**ALASKA DEPARTMENT OF
ENVIRONMENTAL CONSERVATION**

2021 Alaska Regional Haze State Implementation Plan

Appendix III.K.13.K Consultation

Response to Federal Land Managers' Comments on Regional Haze Proposed
Regulations

Long-term Visibility Trends

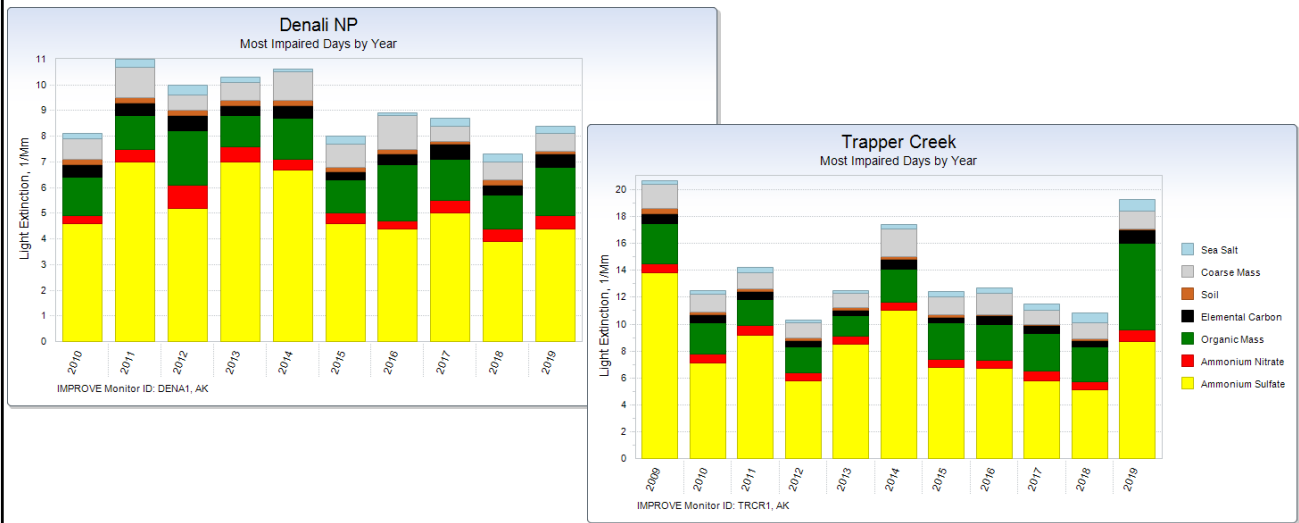
There is a long history of IMPROVE visibility monitoring at Denali NP&P (32+ years).

The regional haze metric is now based on most-impaired days rather than haziest. Still, it is interesting to see the range of visibility conditions experienced by park visitors and monitored in the park. It is also interesting to note the dramatic influence of fire on the haziest days in 2004, 2009, and 2015.
